intel® Technical Advisory

TA-209-1

July 16, 1999

Inserting board stand-offs in incorrect holes or adding additional stand-offs may cause component failures on server boards installed in Astor 2 or Columbus III server chassis

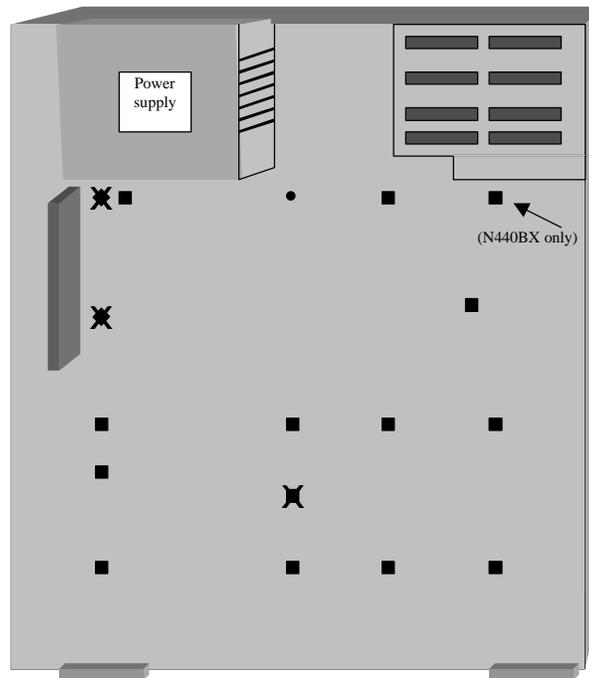
The following diagram shows all stand-off mounting hole locations in both the Astor 2 and Columbus III server chassis. The "X" marks locations that should **not** be used when installing a T440BX, NL440BX, or L440GX+ server board into a Columbus III chassis and N440BX or L440GX+ into an Astor 2 chassis.

Intel will be making a modification to the "Integrators Guide" for both the Astor 2 and Columbus III to better reflect proper stand-off locations.

If a server is experiencing loss of keyboard, mouse, or SCSI functionality, verify that no stand-offs are inserted in locations marked with an "X" in the diagram above. If so, disassemble the server following the safety instructions located in the Chassis Integrators Guide, place stand-offs only in the appropriate locations and reassemble the server.
